OICA Comments, part A

Definition of xEV Battery Durability:

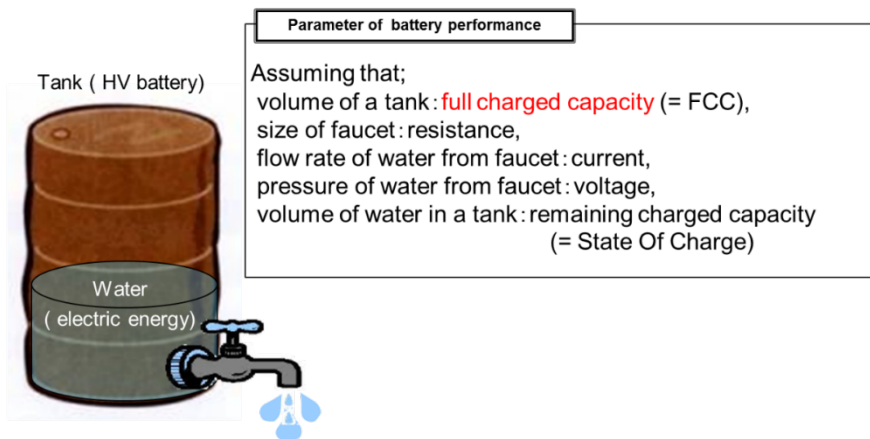
The authors set out the definition of xEV Battery Durability that “The ability of an electrified vehicle battery to withstand degradation of functionality such that power & energy performance targets are met during typical drive cycles, consumer usage, and storage conditions without exceeding its end-of-life cycle and calendar life specifications.”

In testing for battery durability using the above definition, xEVs and their battery systems will be subjected to drive cycles featuring various charge and discharge scenarios along with storage such that a vehicle will be able to (using USABC BEV goals [14] as an example) achieve either ≥ 15 years of calendar (storage) life or continue operating beyond 1000 cycles while maintaining $\geq 80\%$ of its rated capacity and power.

In general, the proposal concept of definition of xEV battery durability is assumed correct, however, it should be added that battery system should be designed by OEM product quality requirement. It means that actual performance target should be determined by OEM in order to adapt required performance.
